DATE: March 16, 2022

AGENDA ITEM #4

TO: Design Review Commission
FROM: Nazaneen Healy, Associate Planner
SUBJECT: SC21-0039 – 217 Pasa Robles Ave

GRADING & DRAINAGE PLAN – OPTION A
 APN 167-15-022
 217 PASA ROBLES AVENUE
 IN THE CITY OF LOS ALTOS, CALIFORNIA

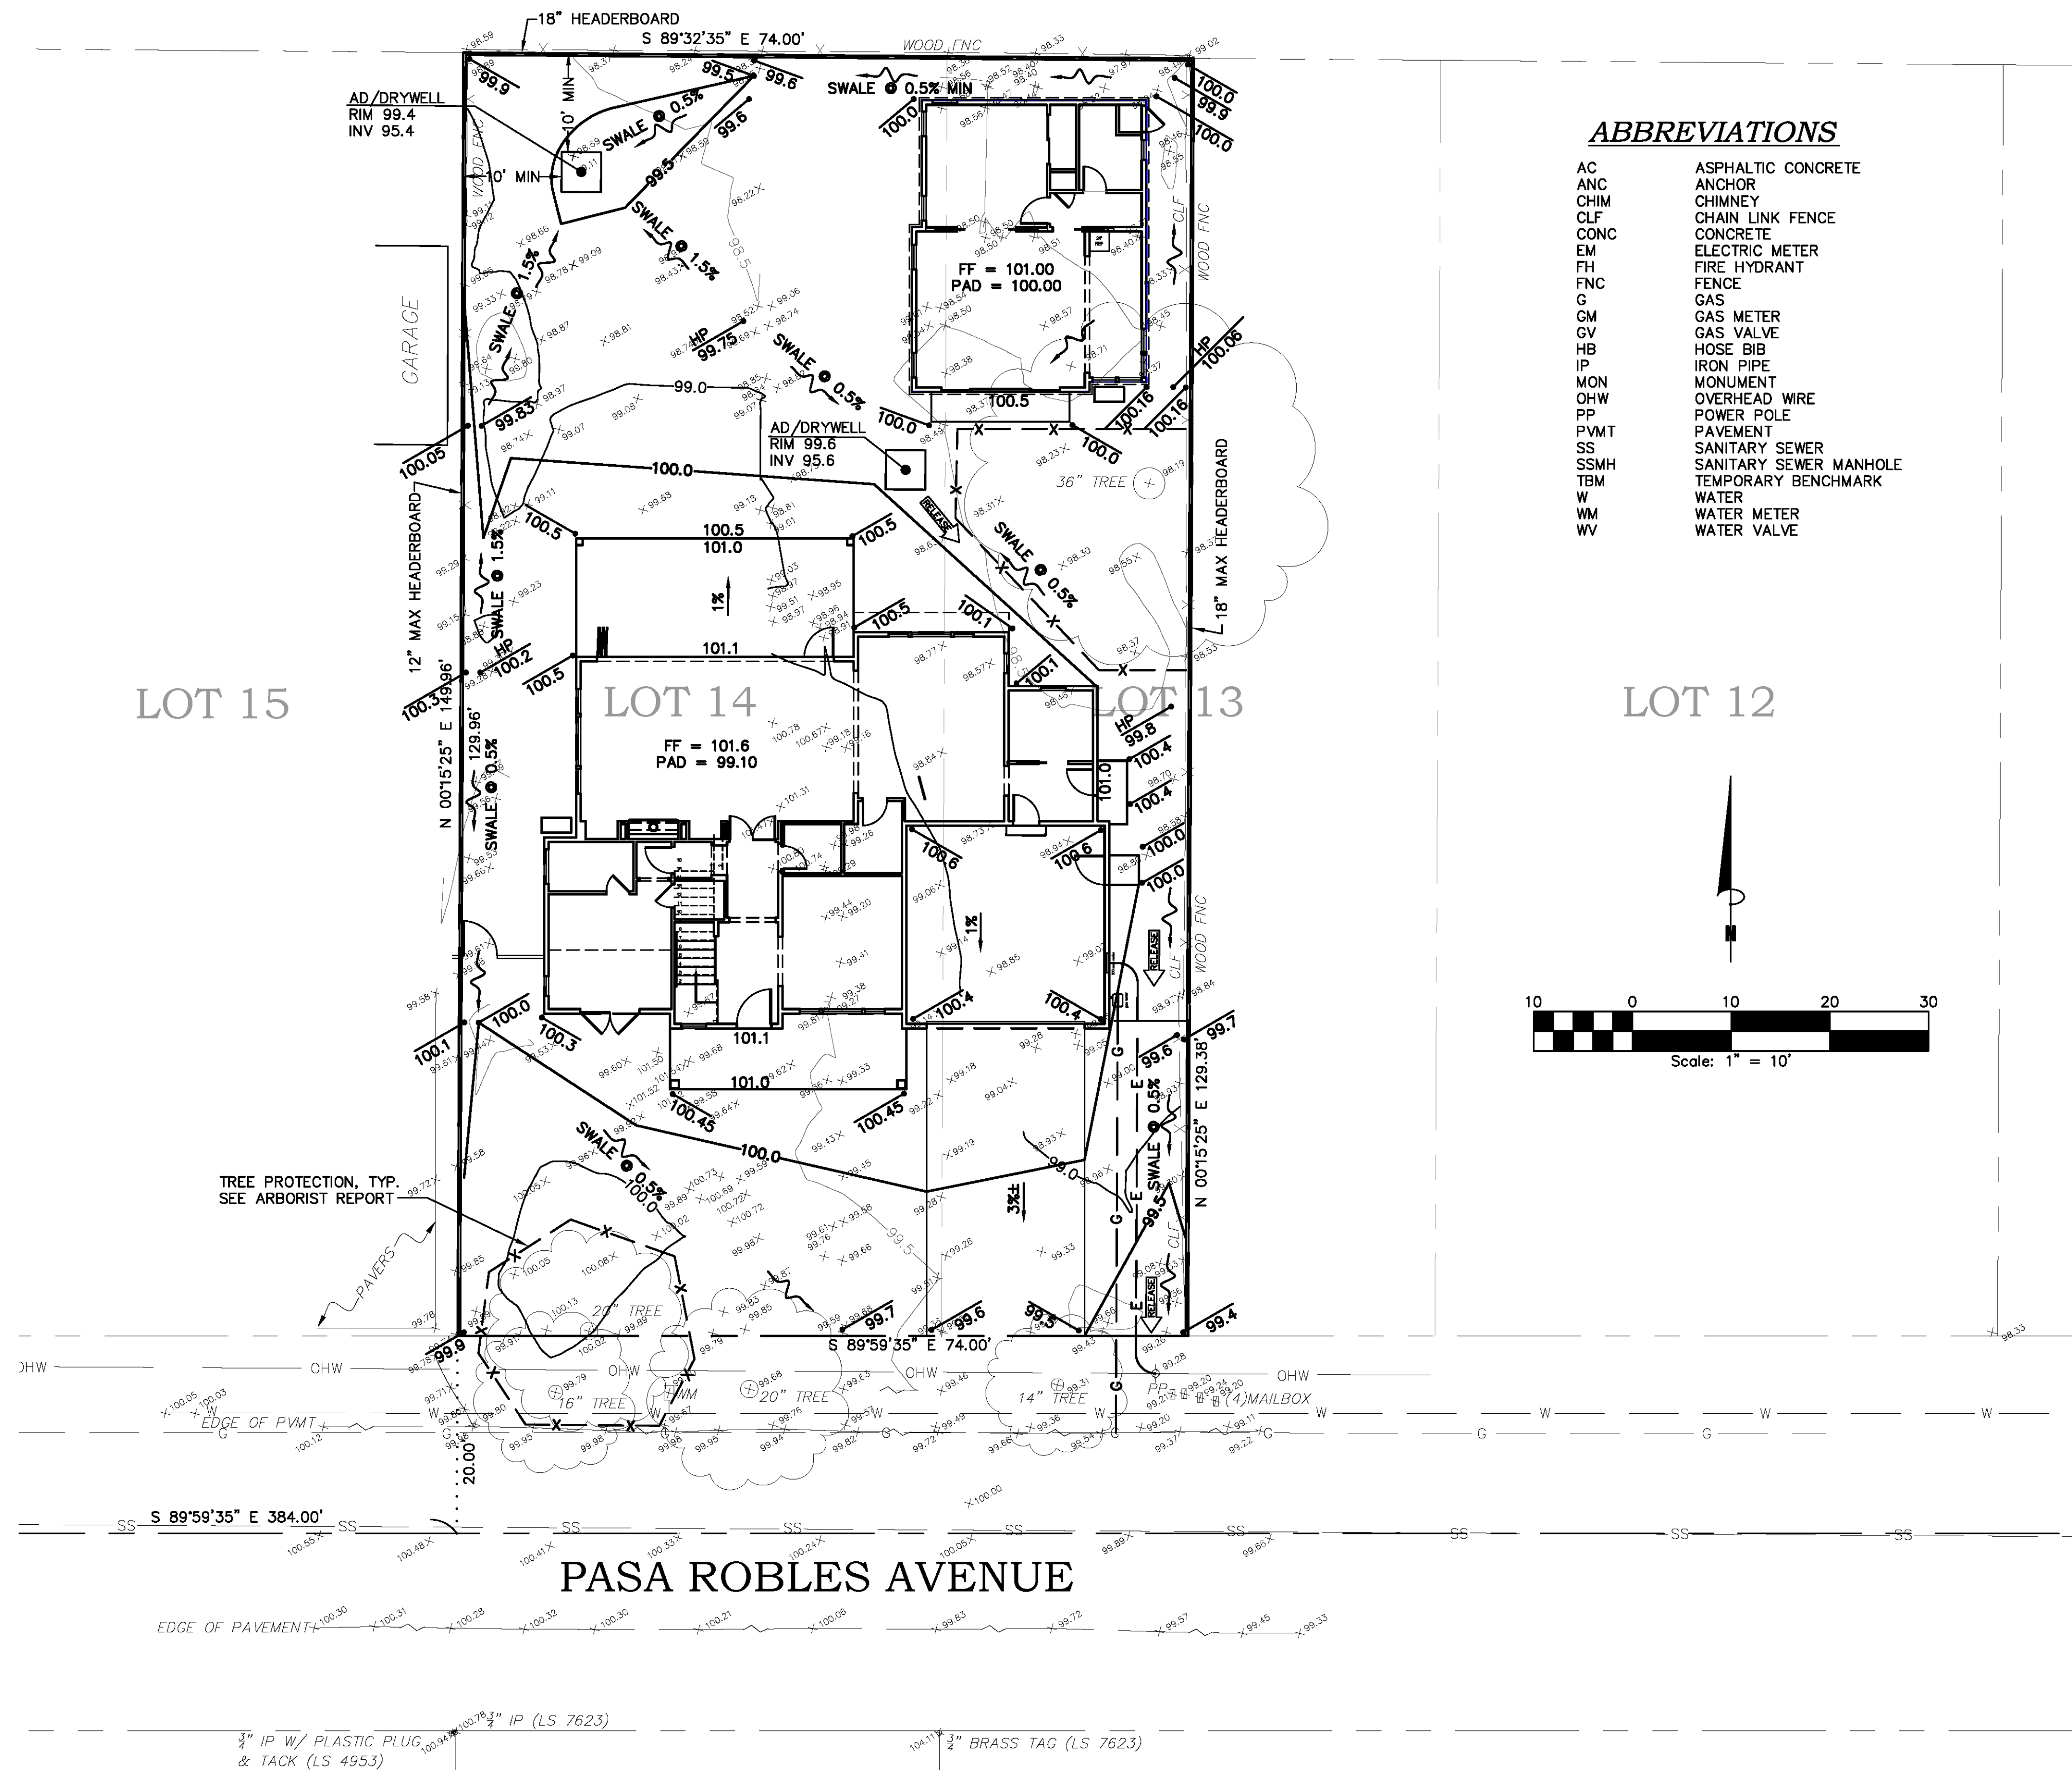
The proposed drawings include two grading plans (Option A and B on Sheet C3A and C3B respectively). Option A proposes to raise the grade one foot along the rear of the property and in response to staff comments, Option B conforms to the existing grades along the property lines. Staff finds Option B to be consistent with the following required Design Review findings pursuant to LAMC Section 14.76.060 which speak to minimizing changes to the existing topography:

properties. Therefore, staff recommends inclusion of Condition of Approval No. 2a requiring incorporation of grading plan Option B into the building permit plans.
